Safety recommendation: AIC 19-R02/18-1004

Addressed to: Honeywell Aerospace

Investigation link: AIC 18-1004

Figure 1: Glideslope and Sink rate aural Alerts graphic plotted using Derived Data (Revised graphic for clarity)

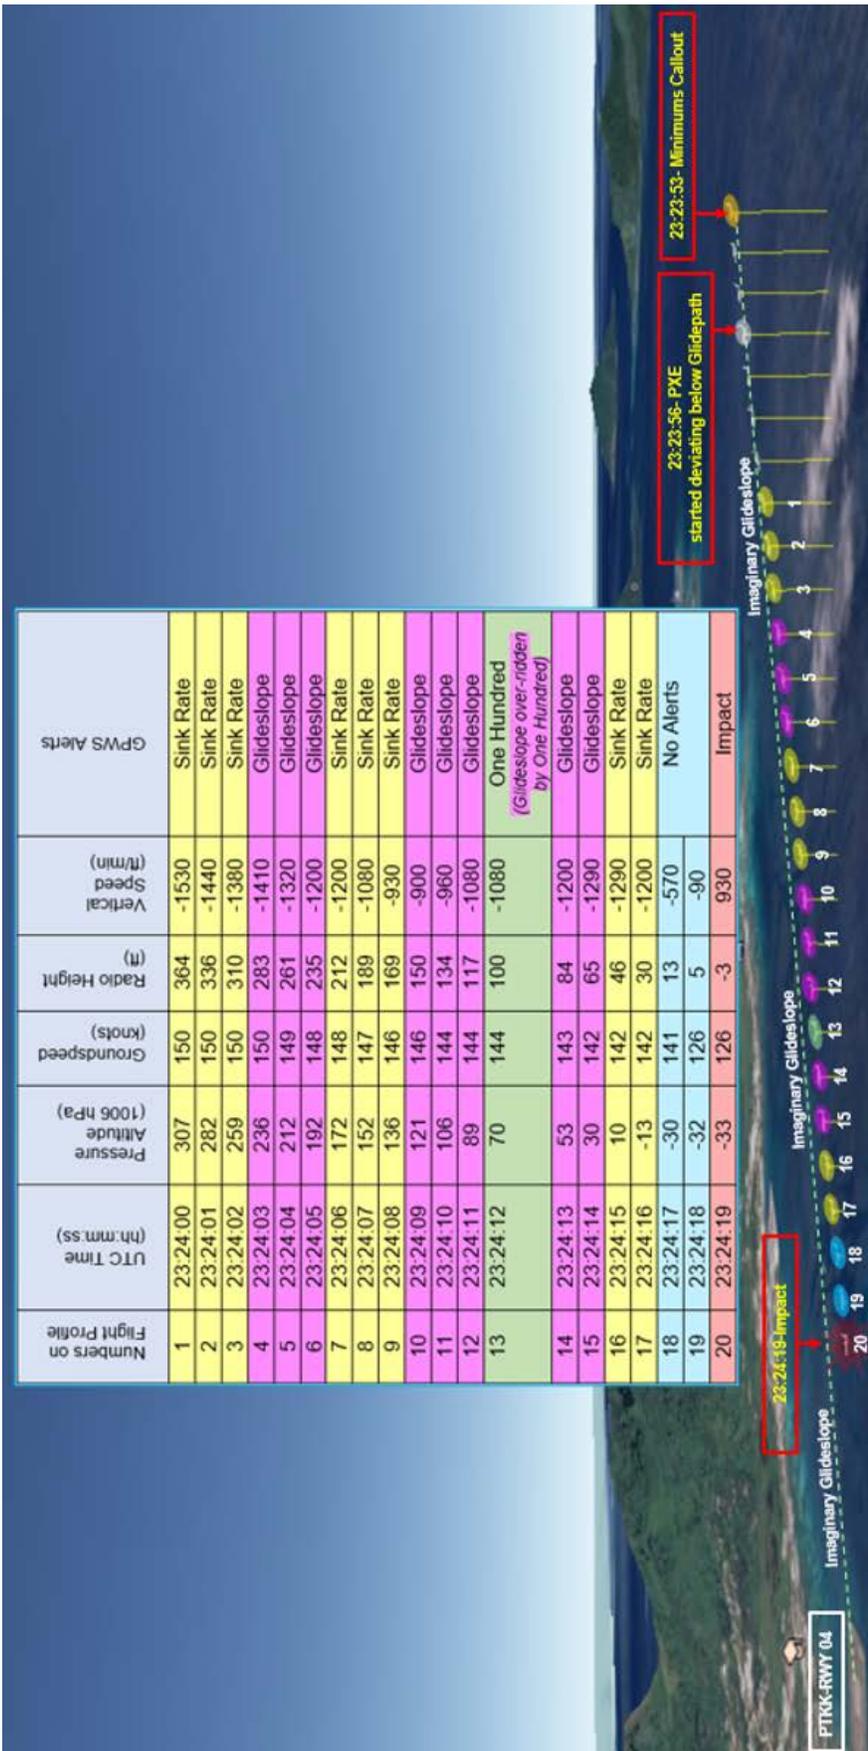
The PNG Accident Investigation Commission recommends that Honeywell Aerospace should ensure that the Honeywell EGPWS MK V Computer provides timely and continuous hard aural warning “*WHOO PULL UP*,” simultaneously with the stable visual display of **PULL UP** on the Primary Flight Display, which requires immediate action from the crew, when encountering an excessive Rate of Descent at very low Radio Altitude, similar to that encountered by the crew of P2-PXE as shown in Figure 1.

The PNG Accident Investigation Commission recommends that Honeywell Aerospace, in consultation with the Federal Aviation Administration, should re-evaluate *TSO’s 151b and 151d* and *DO-367* related to EGPWS warnings and cautions, and ensure that the Honeywell EGPWS MK V Computer provides a **timely warning** in the form of a continuous **flashing** visual display of ‘**PULL UP**’ at the bottom of the Primary Flight Displays, as an absolute minimum standard. The **flashing** visual display ‘**PULL UP**’ warning, simultaneously with the aural caution ‘*SINK RATE*’, would require immediate action from the flight crew when encountering an excessive Rate of Descent at very low Radio Altitude, similar to that flown by the crew of P2-PXE as shown in Figure 1.

Figure 2: Derived Data plotted against Honeywell EGPWS MK V Mode 1 Graph

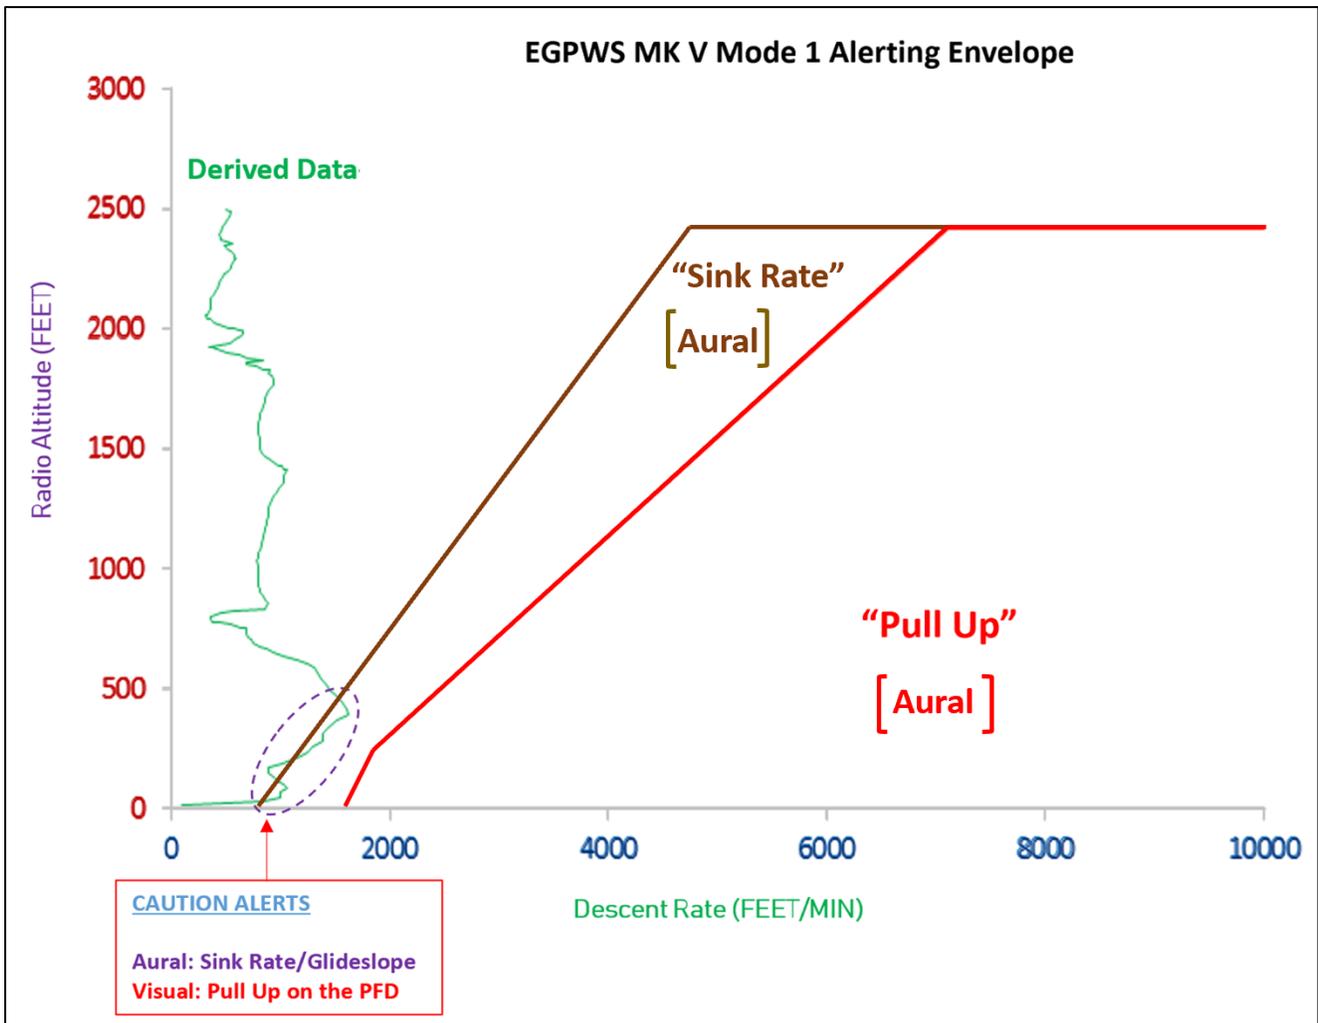
The investigation into this accident has found that the crew did not take any remedial action in response to the *Glideslope* and *Sink rate* Caution Alerts (aural alerts). The EGPWS issued these Caution Alerts (aural alerts) that included the words **PULL UP** appearing steady in red on the Primary Flight Display (*Electronic Flight Instrument System*) when the aircraft penetrated the Sink Rate Envelope of the *Honeywell EGPWS MK V Mode 1 Graph*. See Figure 2.

As per *DO-367 ‘Must Not Alert (Warning)’ requirement* region (as depicted in Figure 2), with the engine spool-up time and the time it will take to compensate for the loss of altitude for a positive rate of climb, there is insufficient time for pilots to react to an immediate time-critical situation if there is no ‘WARNING’ alert issued at low altitude after entering the *DO-367 ‘May Alert’ and ‘Must Alert’* regions. The rate of descent during the approach into Chuuk as shown in Figure 1, clearly shows that the crew were outside the safety margin.

Figure 3: Mode 1 Sink Rate Alert Curves with DO-367 “Must Not Alert (Warning)” Requirement¹¹

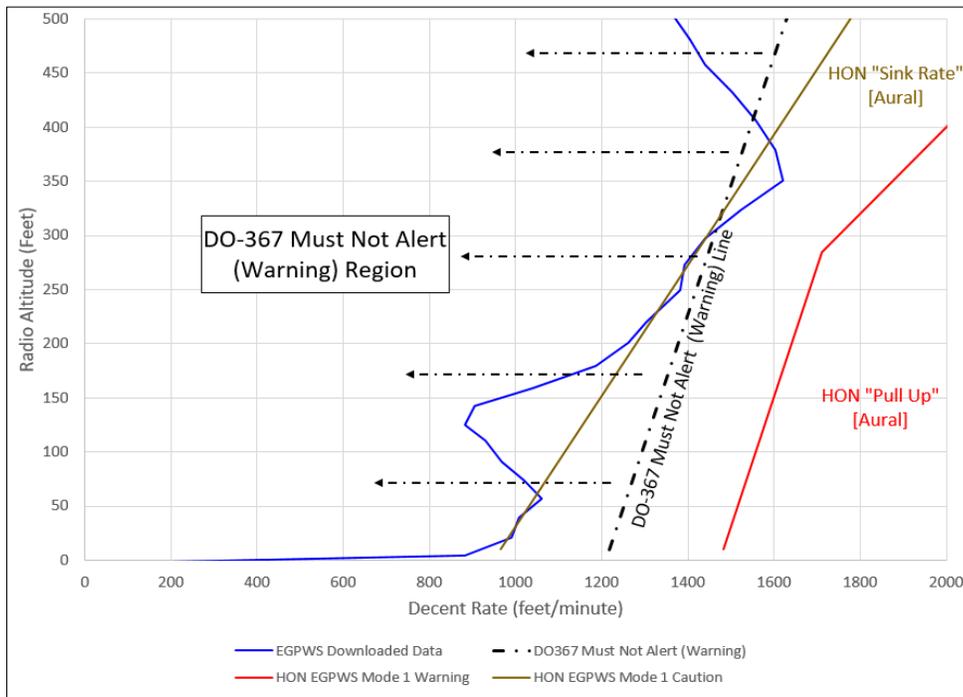
‘if the Warning curve were to be modified to exactly match the DO-367 “Must Not Alert” warning requirement, it would result in more nuisance “PULL UP” alerts being generated which would disturb the crew during normal operations and violate the requirements of the TSO-151d.’

The logical reasoning for an alert to be interpreted as ‘nuisance’ from an operational perspective is for the pilots to determine whether an alert is a nuisance. It is not logical to term an alert as ‘nuisance’ when it is pointing out an unsafe situation. The chart in **Figure 2** of the Honeywell response shows the DO-367 ‘Must Not Alert’ region against Honeywell Aerospace EGPWS Mode 1 alerting graph. However, it is precisely in that zone, at the low altitude and excessively high rate of descent (as depicted), that PXE descended and continued to descend in IMC.

Figure 3 depicts the **HON “Pull Up” [Aural]** boundary of the HON EGPWS Mk V Mode 1 Warning.

- At 275 feet Radio Altitude and 1,750 feet/min rate of descent the time to impact would be 9.4 seconds.
- At 200 feet Radio Altitude and 1,650 feet/min rate of descent the time to impact would be 7.2 seconds.
- At 100 feet Radio Altitude and 1,750 feet/min rate of descent the time to impact would be 9.4 seconds.
- At 50 feet Radio Altitude and 1,500 feet/min rate of descent the time to impact would be 2.0 seconds.
